Addendum No. 001

Subject: William Rowen School – Classroom Modifications
SDP Contract Nos. B-063C, B-066C of 2017/18

This Addendum, dated May 9, 2018, shall modify and become part of the Contract Documents for the work of this project. Any items not mentioned herein, or affected by, shall be performed strictly in accordance with the original documents.

A601

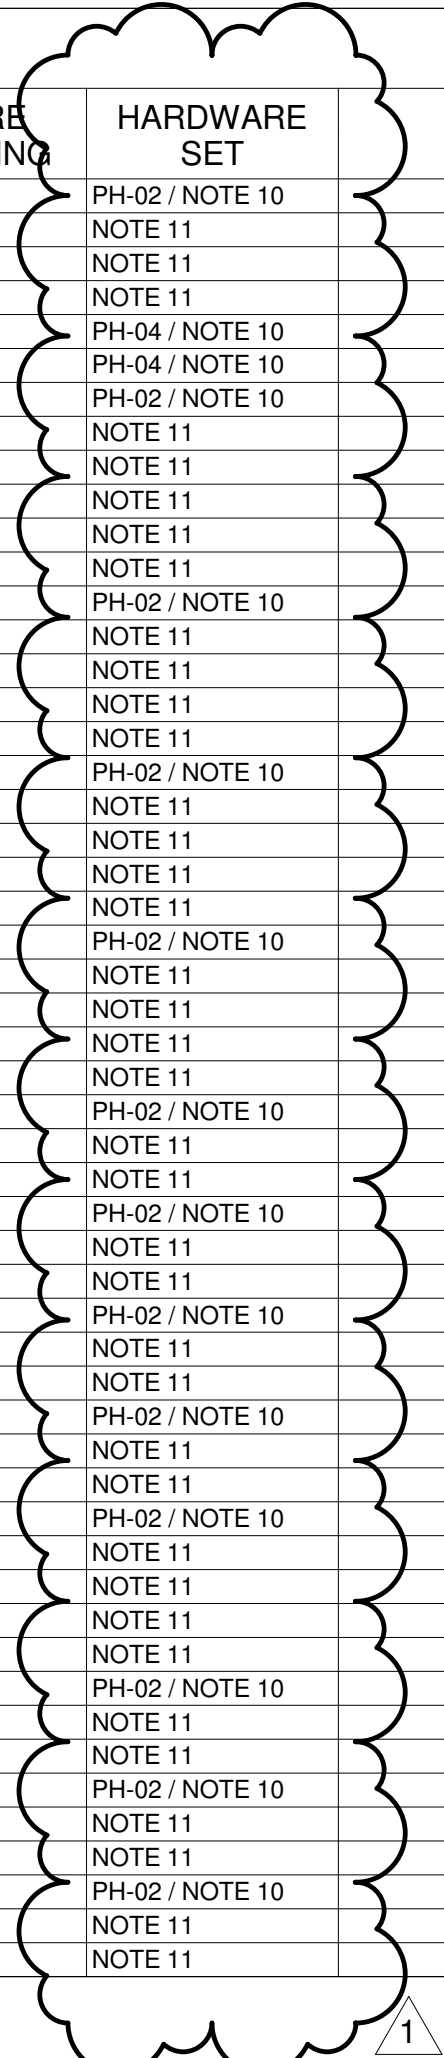
- a. Door and Frame Schedule: See attached revised drawing A601 for added "Hardware Type" column.

DRAWING NO.
ED111

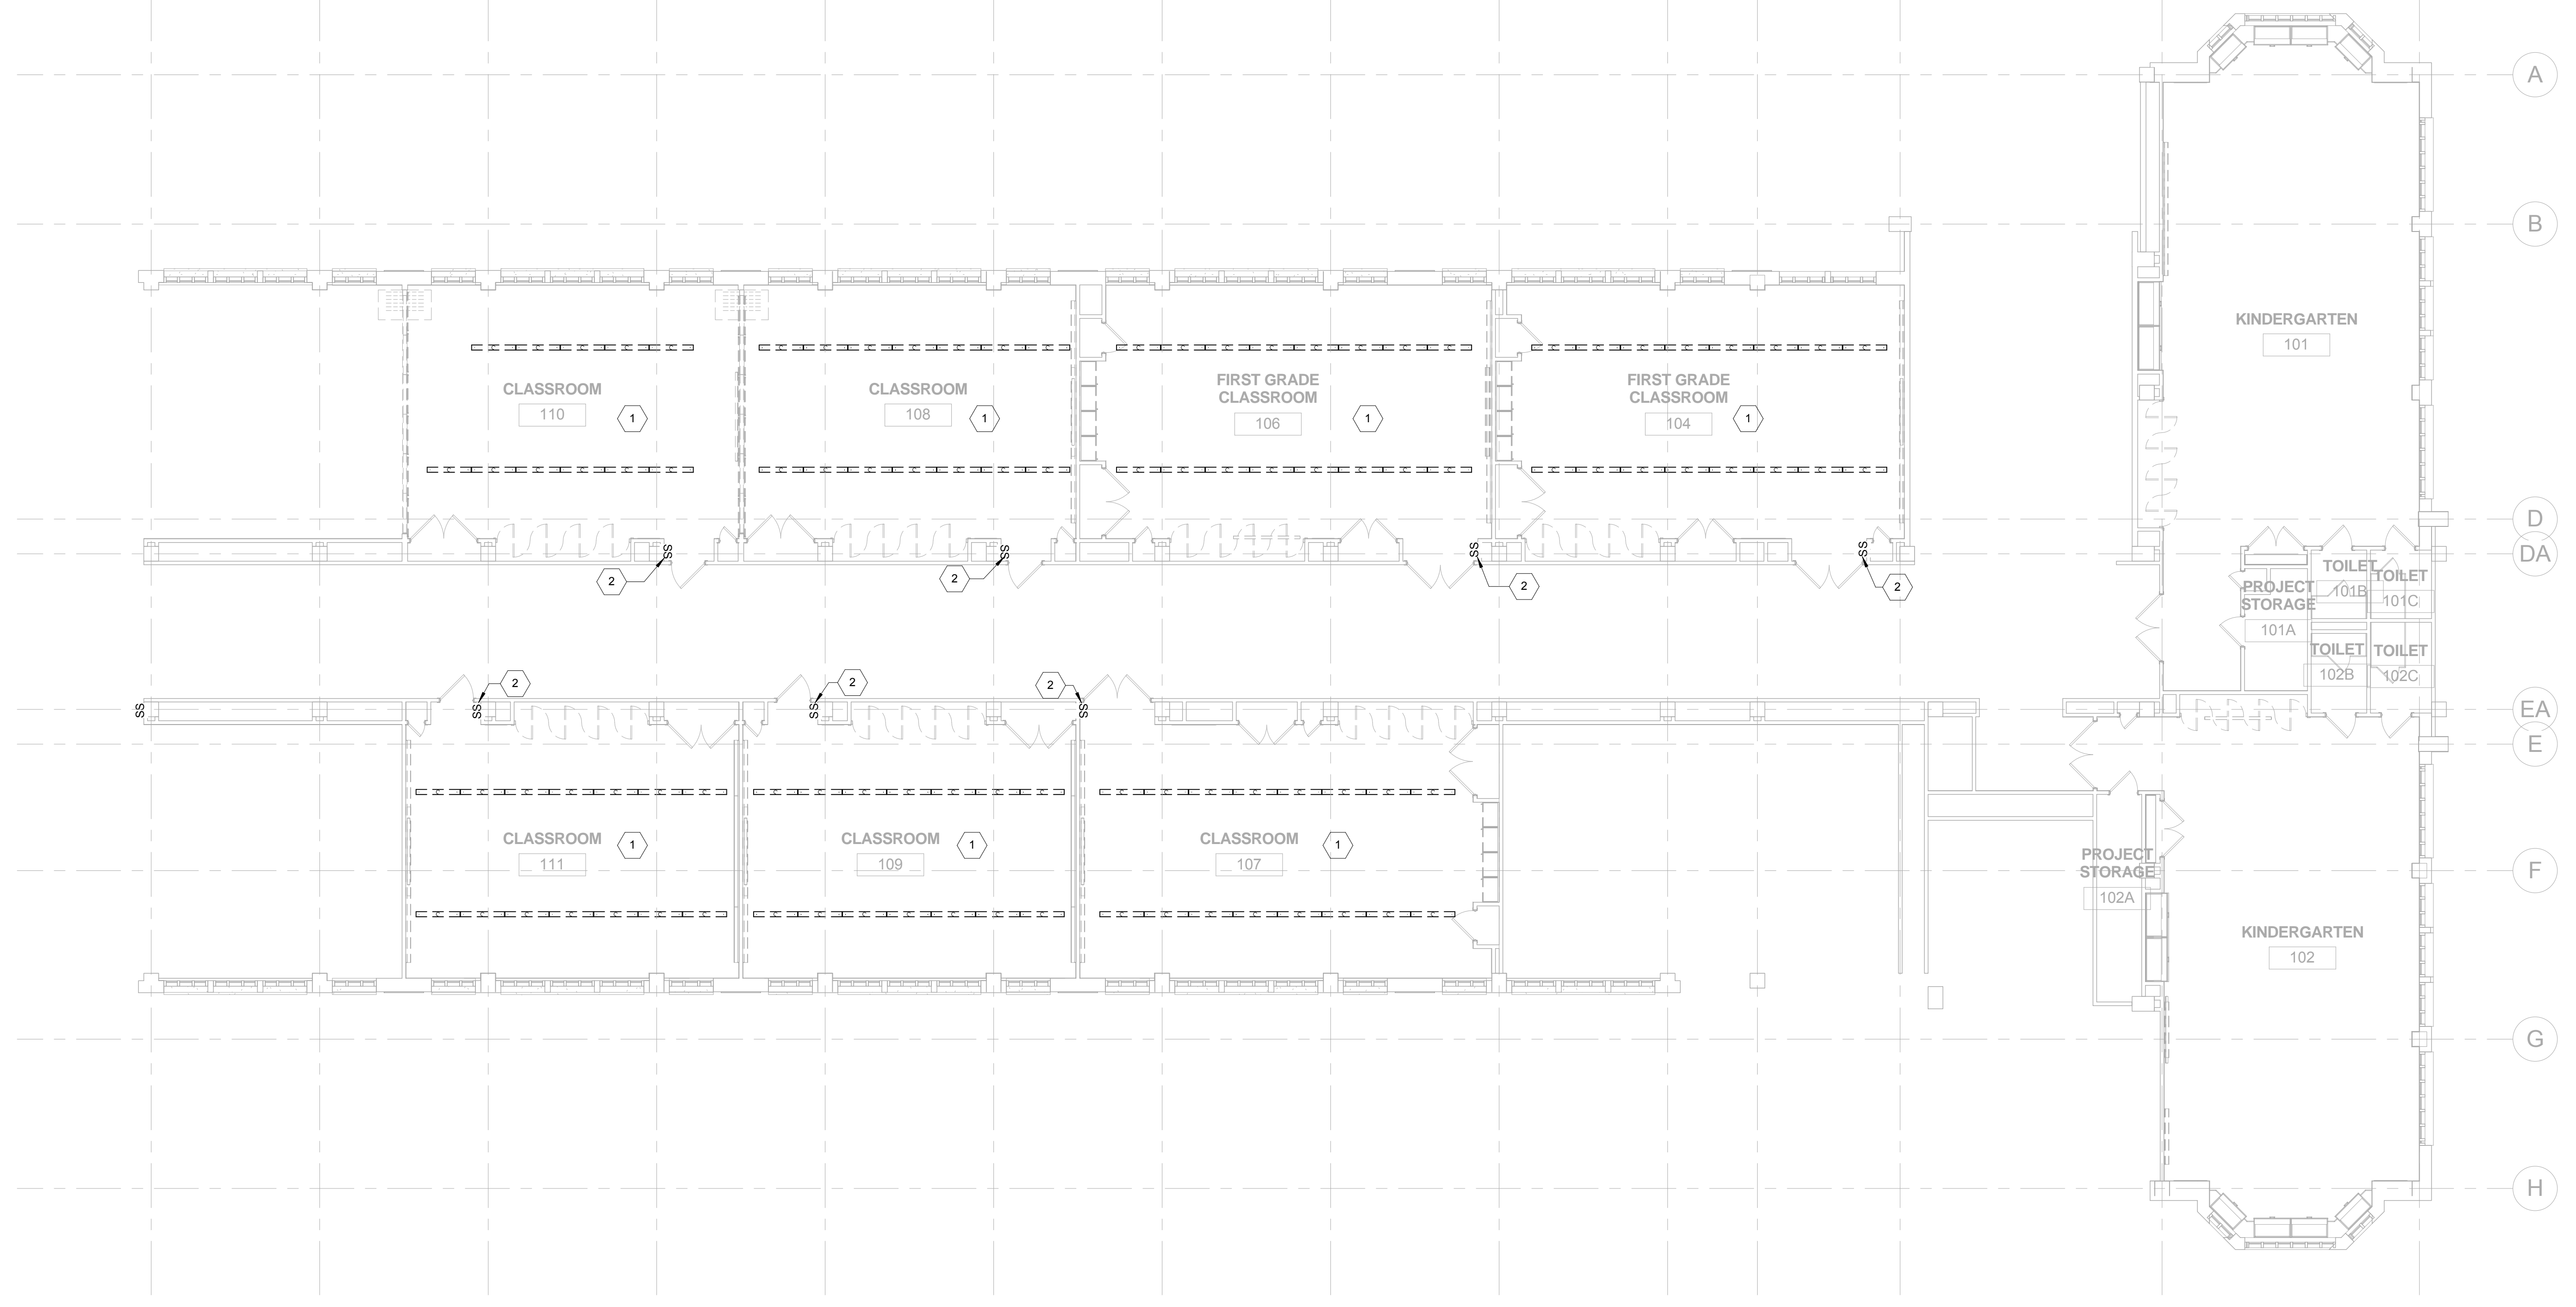
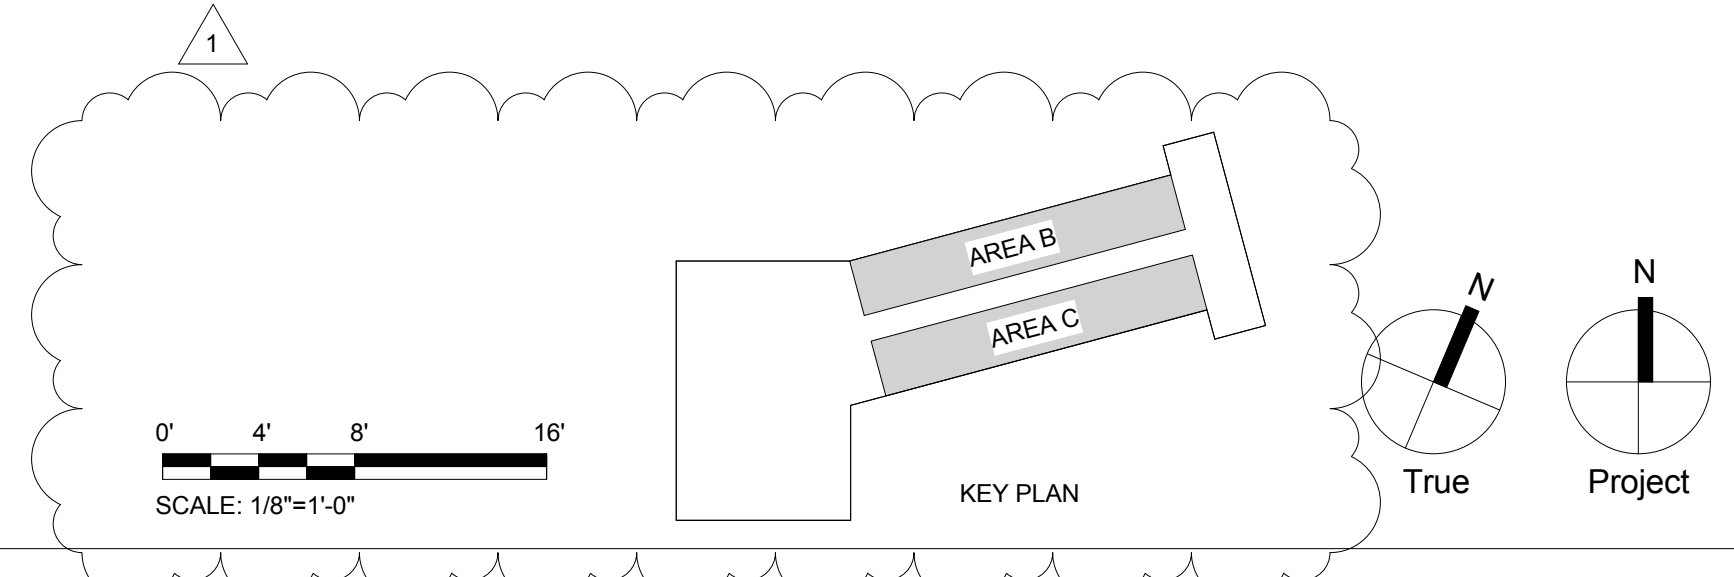
- a. Add key plan.

DRAWING NO.
ED112

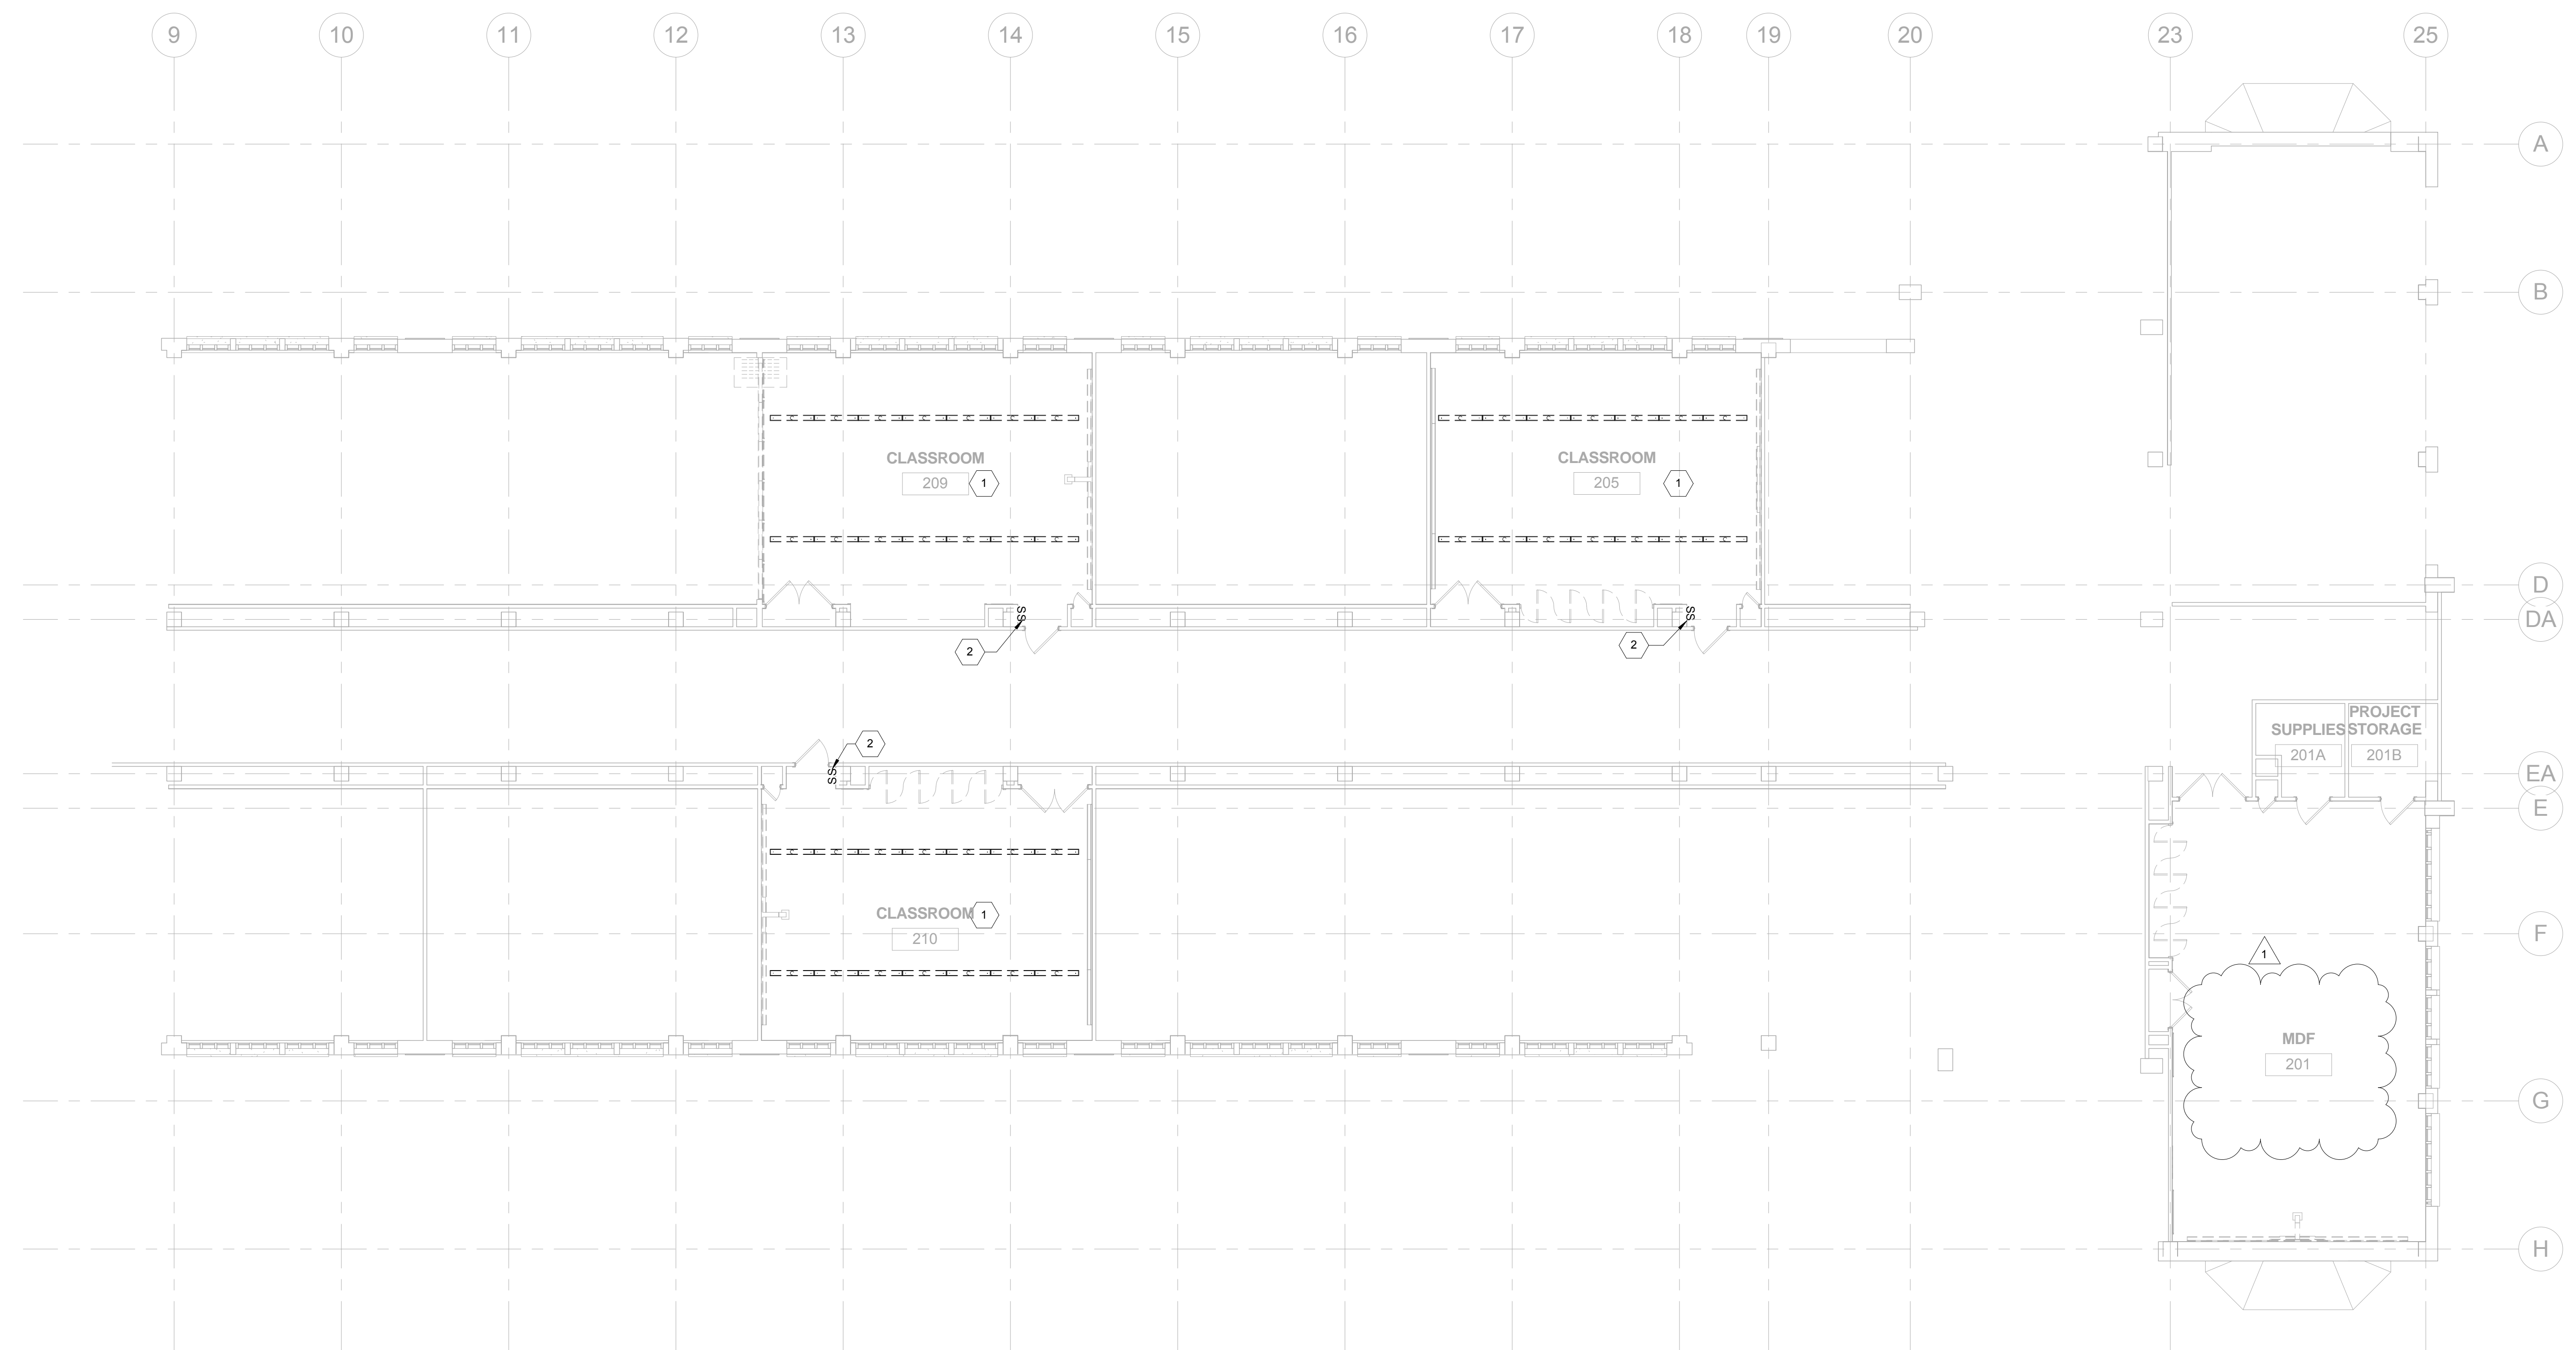
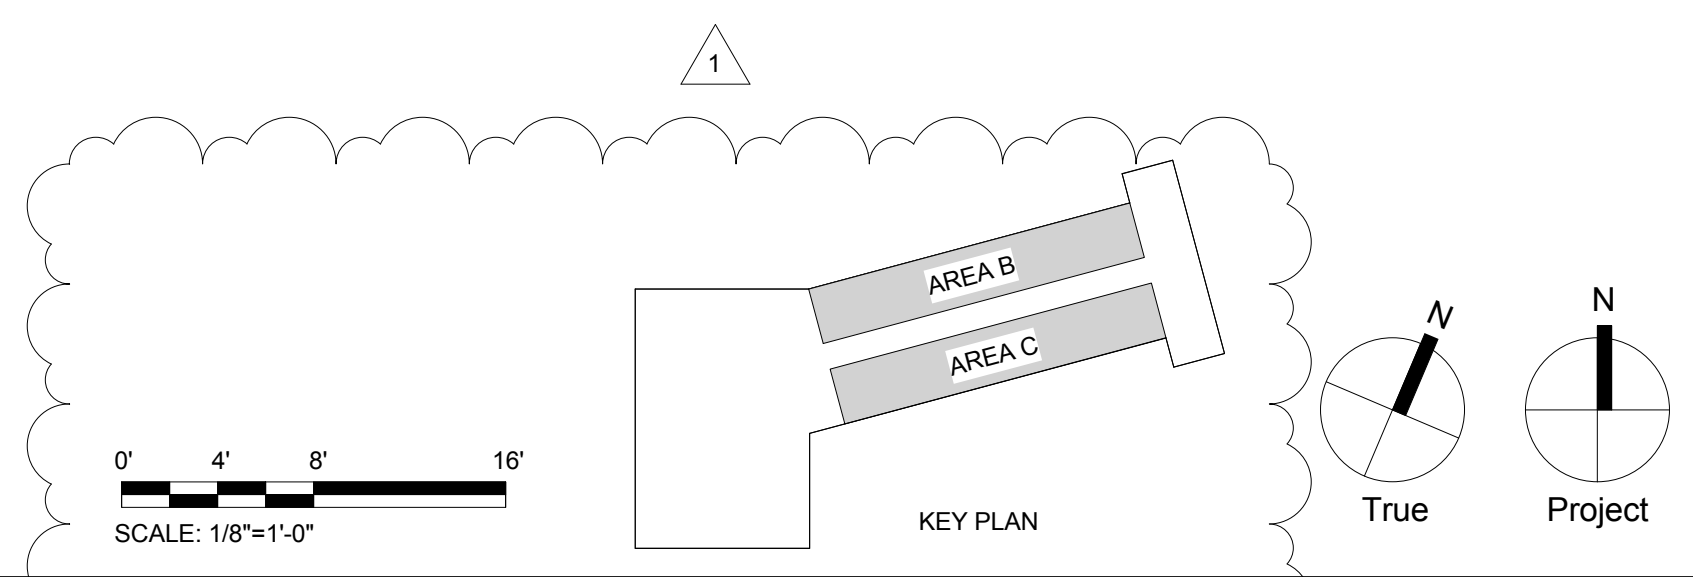
- a. Added MDF room 201.
- b. Add Key plan.
